SERVICE INFORMATION

▲ = Revised May 2000

Sensor Failures in MEFI-3 Mercury Distributors Used on V6 and V8 305/350 cid Engines

- a** - Mounting Screws.
- b** - Rubber Gasket on Sensor.
- c** - Distributor Housing.
- d** - Push Sensor Outward.

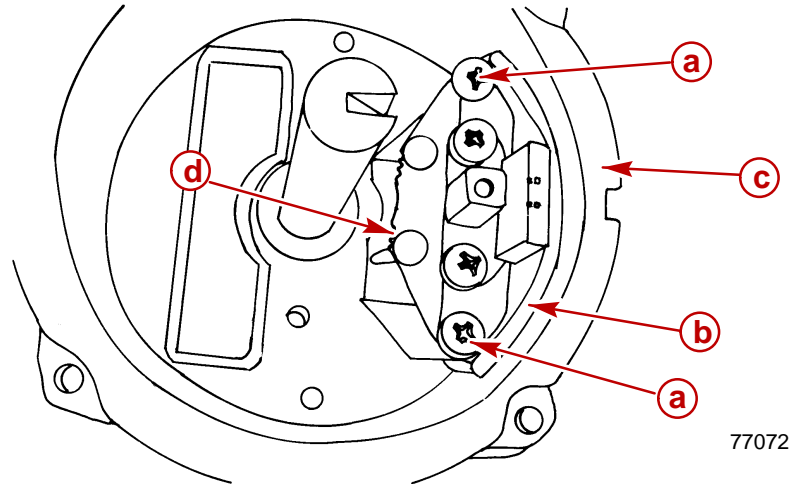
▲ **IMPORTANT:** To make sure that the 'fingers' on the rotor/sensor wheel do not touch the sensor when the engine is cranked, follow the directions below.

▲ During installation, push sensor outward until the rubber gasket is slightly compressed against the distributor housing then tightening the sensor mounting screws
